Access Compliance Report

Public Rights-of-Way

Intersection ID: 48416	Main Street: YORK_CROSSING_DR	Cross Street: S_TRYON_ST	Location: SW
ADA ID: 3AF50E019618	Ramp Type: Perp	Initial Pass/Fail: Fail	Overall Compliance: No
Severity Score: 12.5			
Codes/Mitigation Info/Possible Solution		Field Measurements/Component Compliance

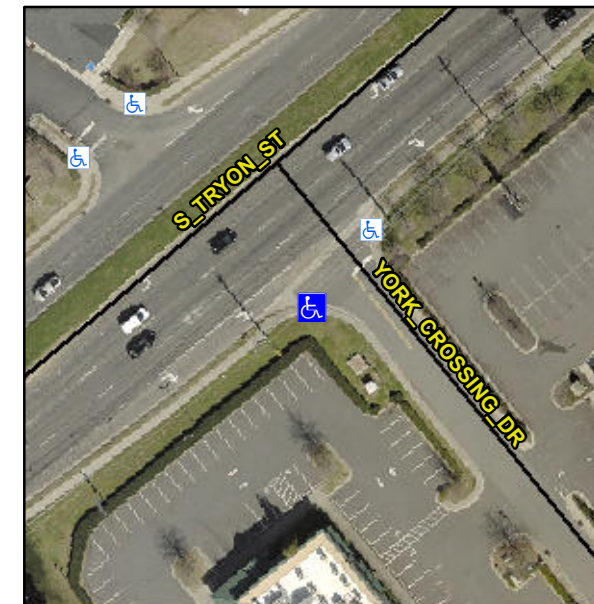
R304.5.3

Remove & Replace Entire Ramp.
